**Addendum No. 01**

Subject: **Marin Classroom Modernization Project  
B-024C, B-025C of 2018/19**

Location : **Marin Elementary School  
3<sup>rd</sup> and Ontario Streets  
Philadelphia, PA 19140**

This Addendum, ***dated February 2<sup>nd</sup>, 2019***, shall modify and become part of the Contract Documents for the work of this project. Any items not mentioned herein, or affected by, shall be performed strictly in accordance with the original documents.

A  
B  
C  
D  
E  
F

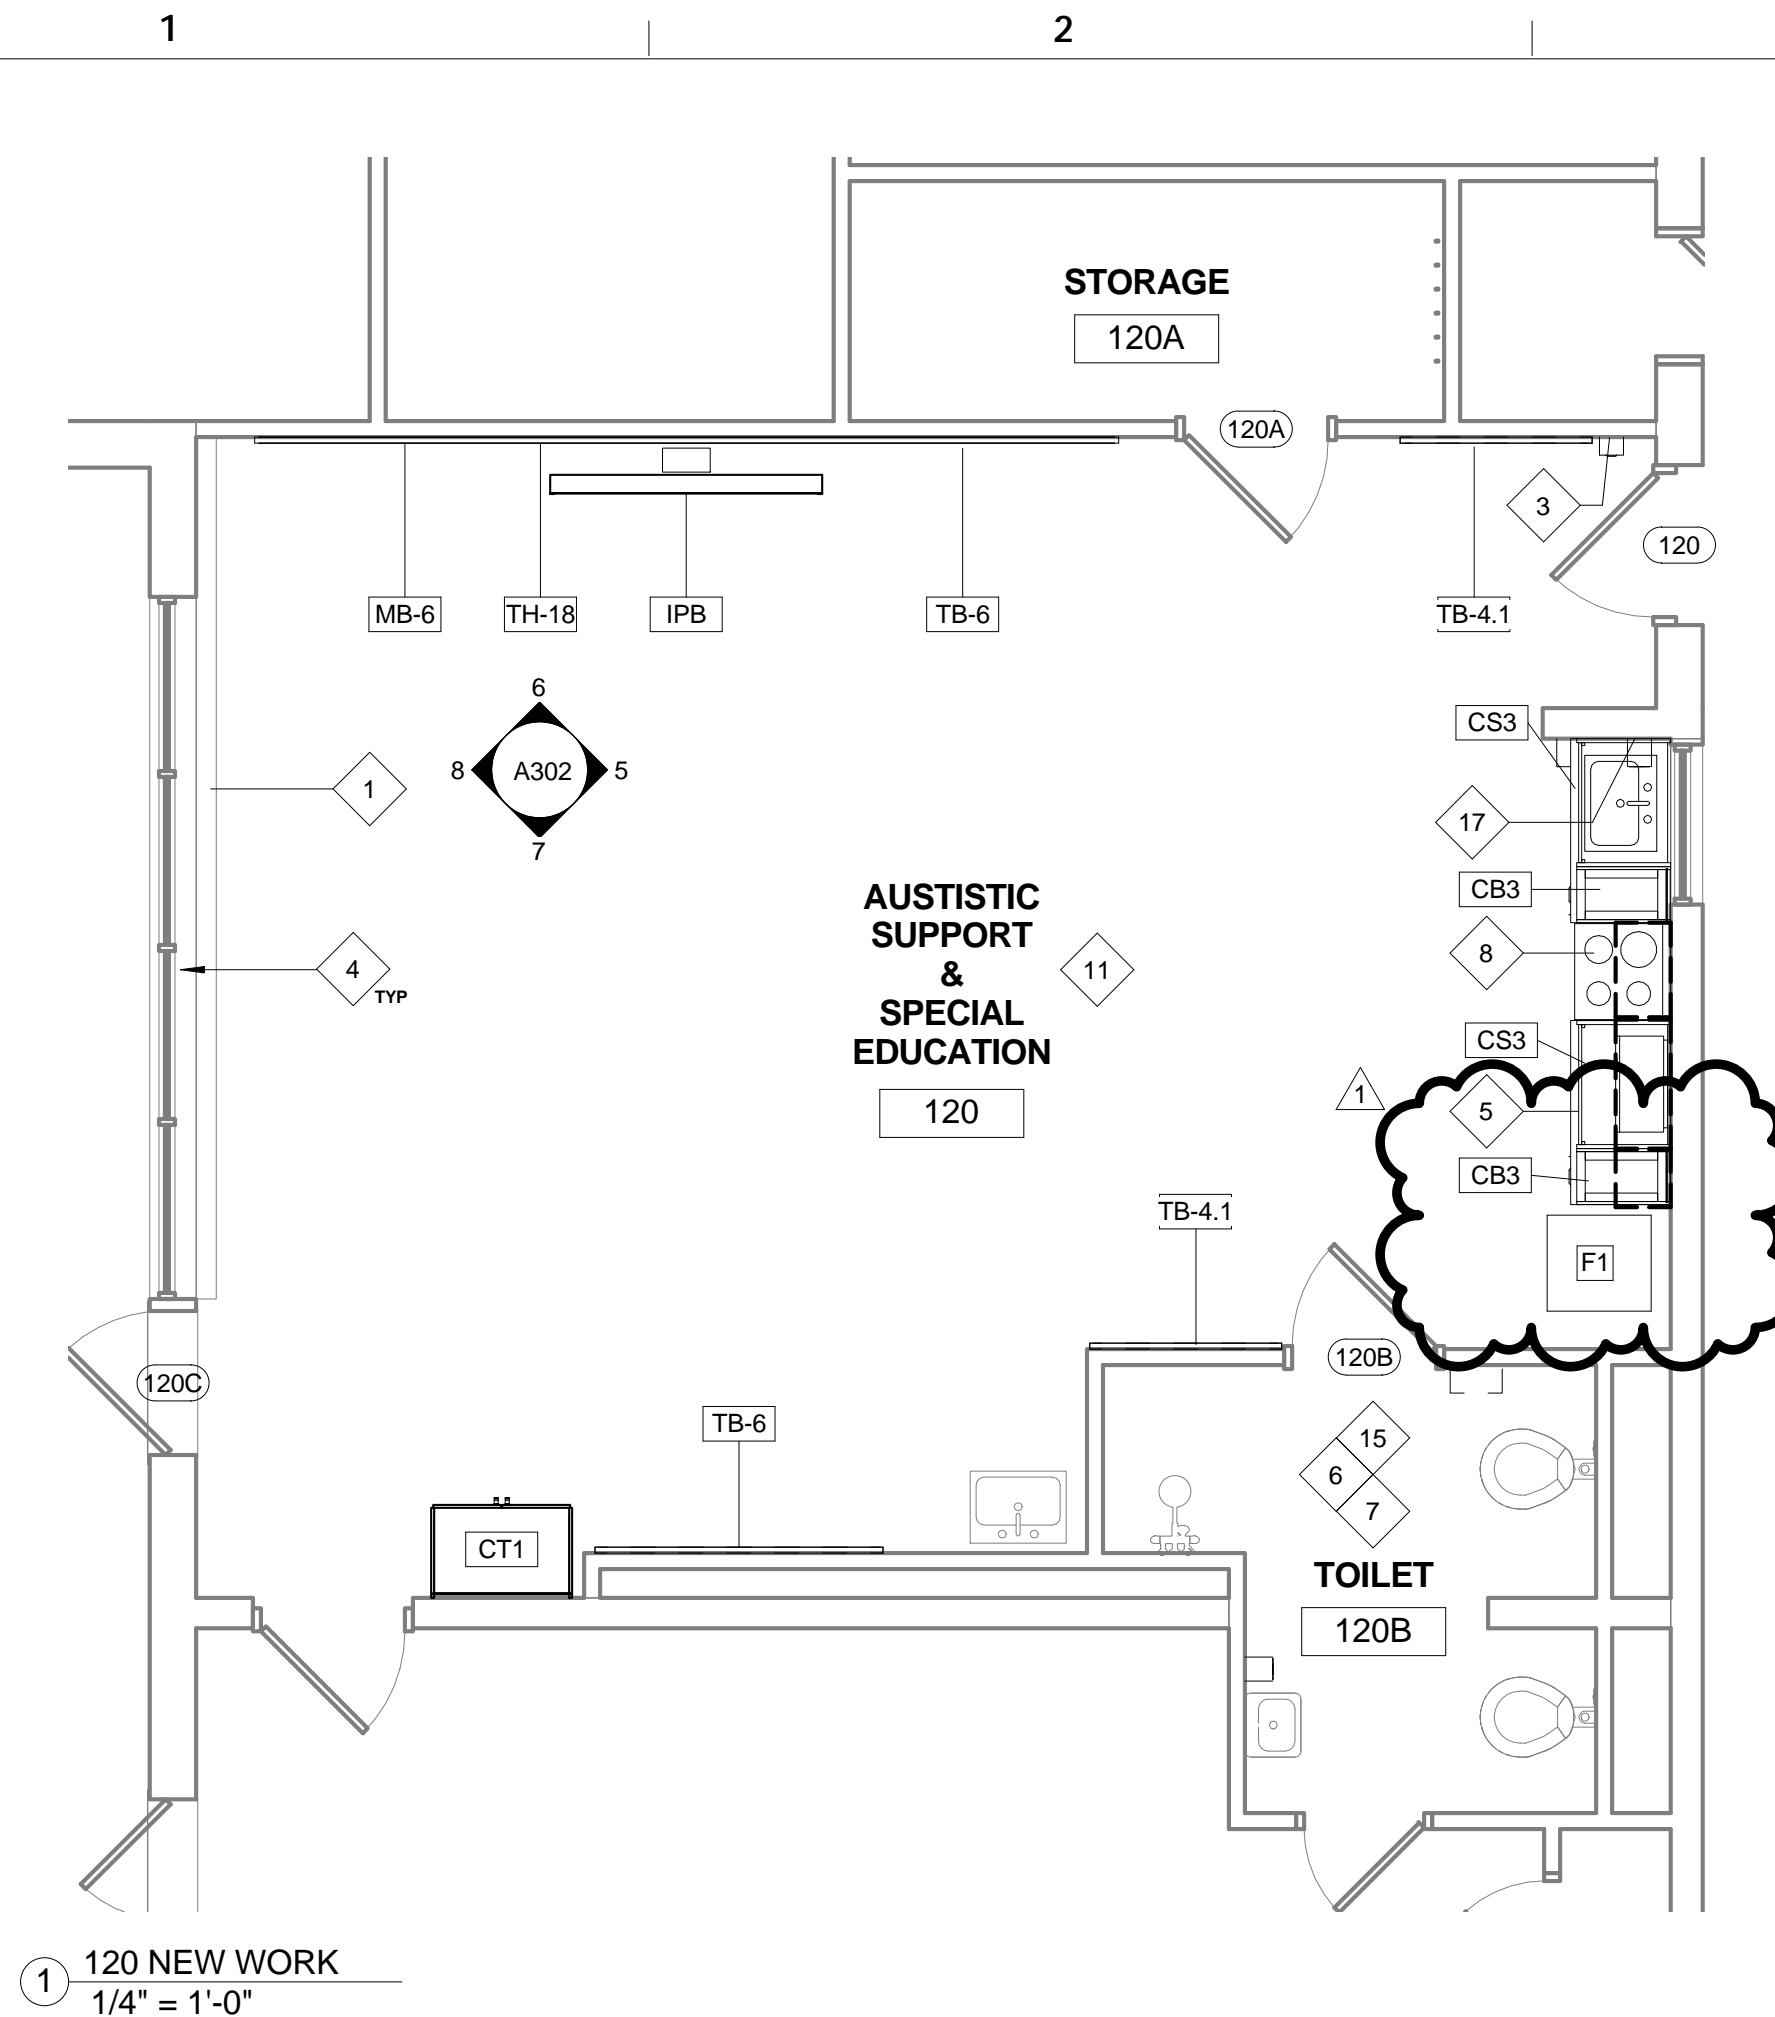
DETAIL 1 IS REVISED, SEE A101 REV 1 ISSUED WITH THIS ADDENDUM.

DRAWING TITLE <b>FIRST FLOOR DEMOLITION PLAN</b>	
DRAWING SCALE AS INDICATED	
LOCATION NO. XXXX	FILE NO. XXX
DRAWN BY NG	CHECKED BY SA
GC B-024 C OF 2018 / 19	EC B-025 C OF 2018 / 19
DRAWING NO. <b>ED - 101.0</b>	
SHEET 19 OF 27

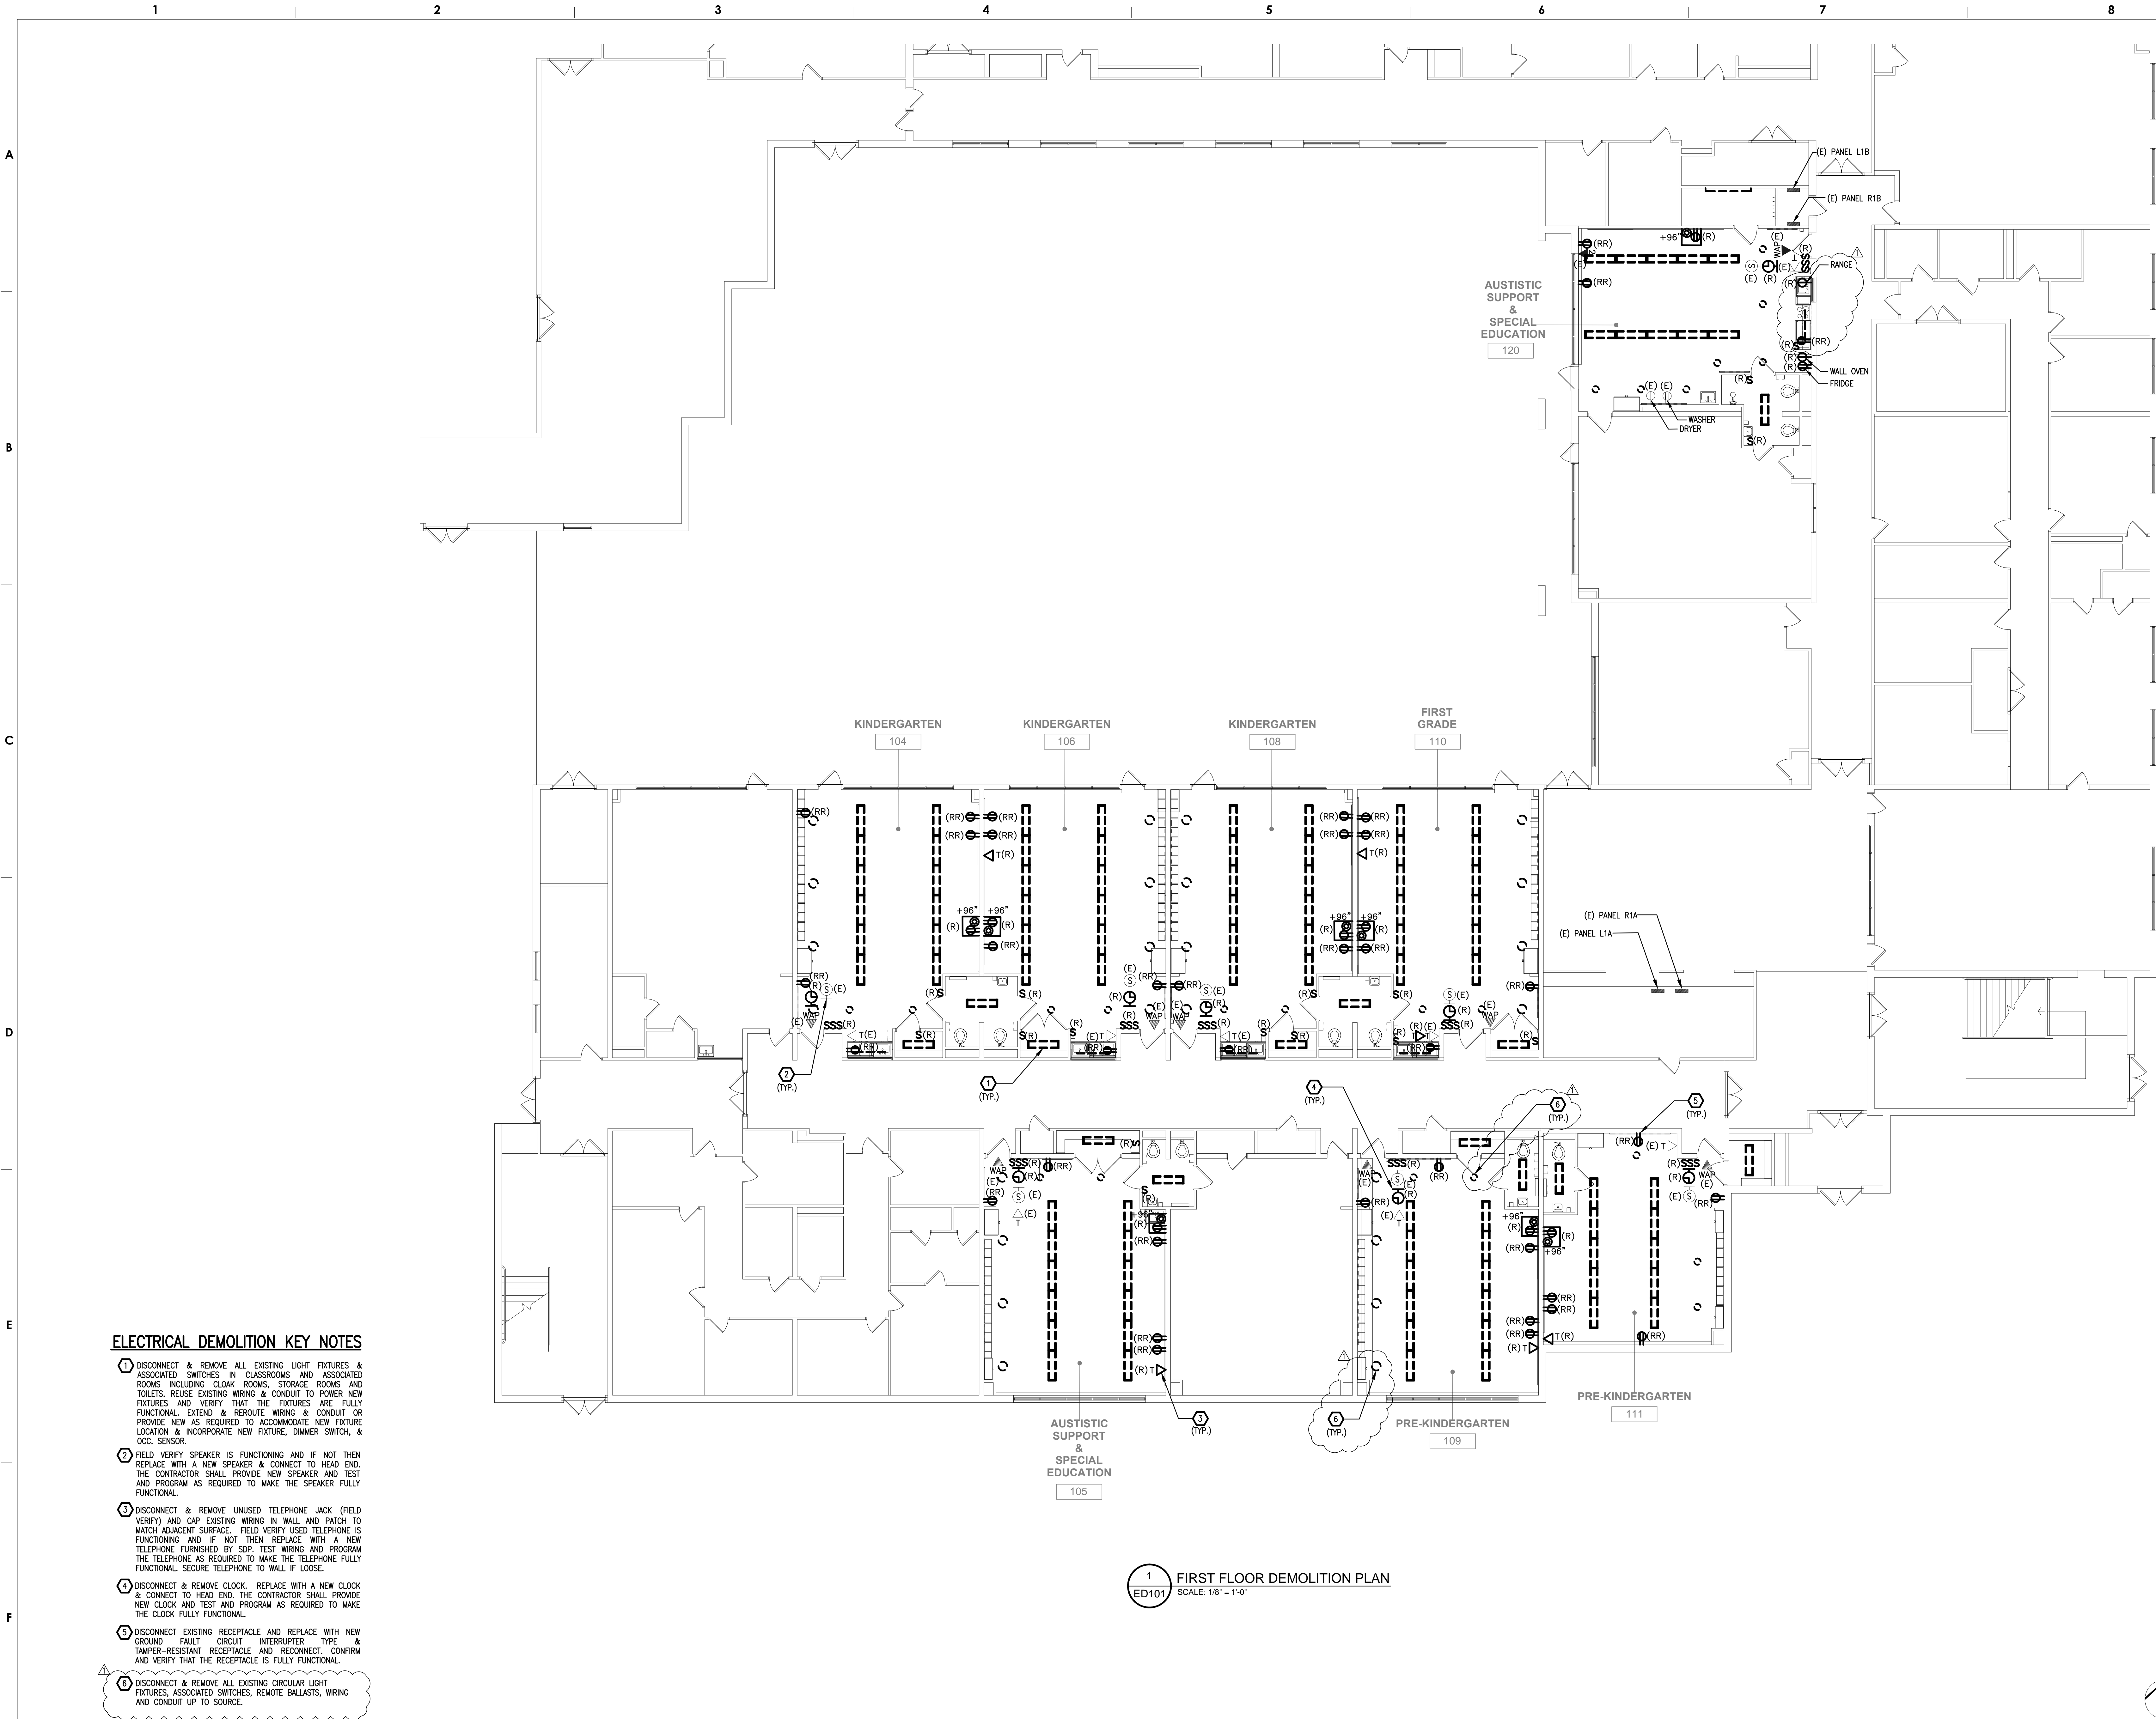
**For changes see drawing ED101.0 Rev1 dated 2/8/19 issued with this Addendum.**
